## NFPA<sup>®</sup> 59A

# Standard for the Production, Storage, and Handling of Liquefied Natural Gas (LNG)

2009 Edition

**Errata No.:** 59A-09-1

**Figure A.10.7.2(d) Full Containment Container.**

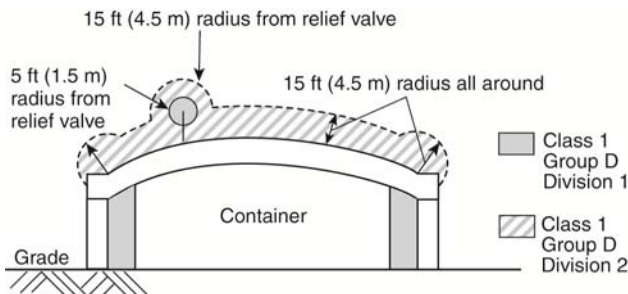
1. In Figure A.10.7.2(d) change the figure to show that the text tag for the darker shaded circle should be 5 ft (1.5 m) as follows:
